<b>Docket Number:</b>	19-OIR-01
<b>Project Title:</b>	Load Management Rulemaking
<b>TN #:</b>	237457
<b>Document Title:</b>	Steve Uhler Comments - OIR-19-01 Latency and Normalization, Report Performance
<b>Description:</b>	N/A
<b>Filer:</b>	System
<b>Organization:</b>	Steve Uhler
<b>Submitter Role:</b>	Public
<b>Submission Date:</b>	4/15/2021 8:22:26 AM
<b>Docketed Date:</b>	4/15/2021

# OIR-19-01 Latency and Normalization, Report Performance

Image taken from TN237439

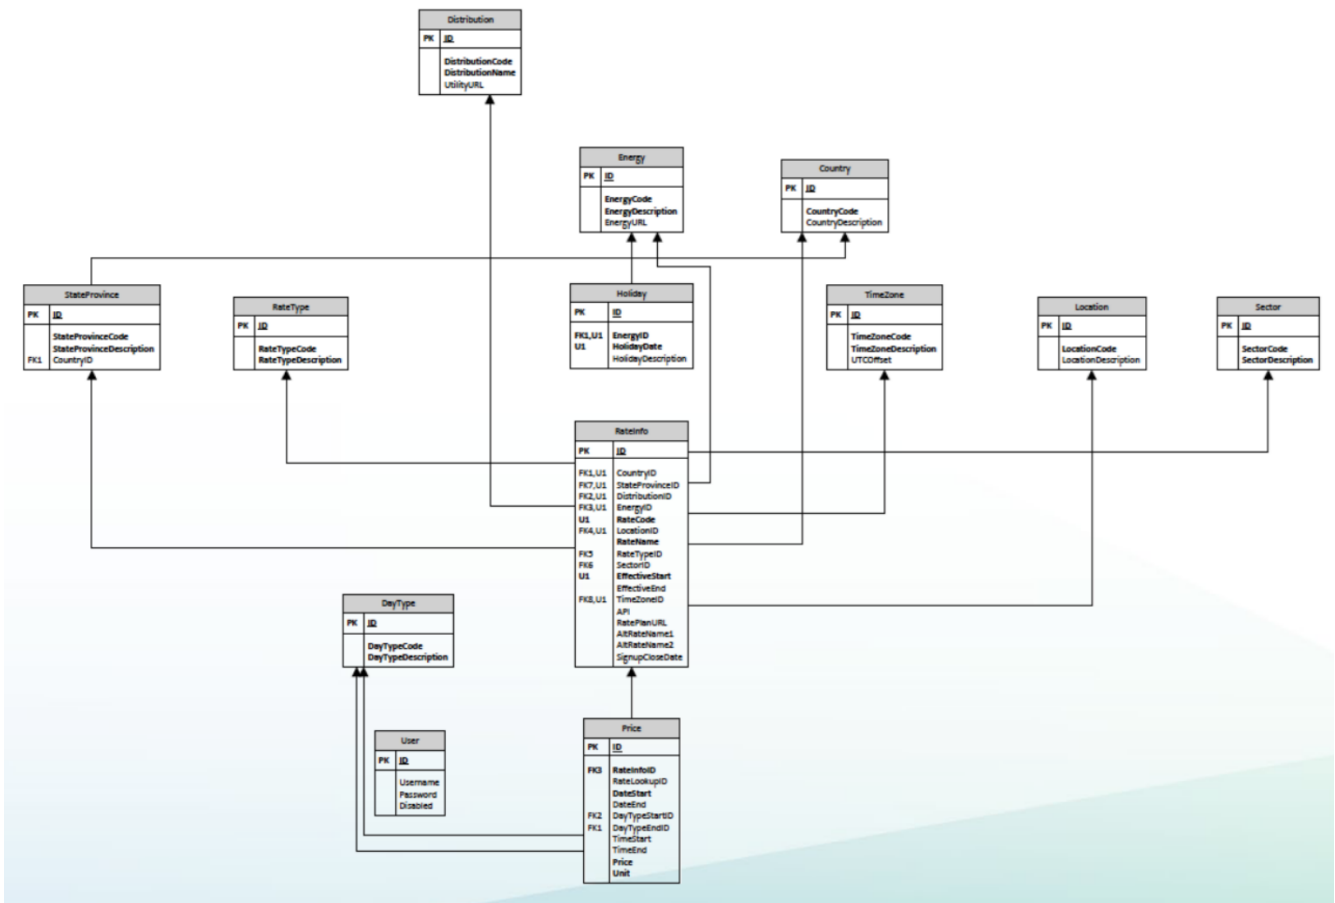
The structure shown below, will not have the shortest possible latent period.

The structure is over normalized. This means queries will take more steps through table joins that would be better served by combining components of subjects such as location in one table.

Please post proposed report prototypes MIDAS database is intended to support in docket for 19-OIR-01.
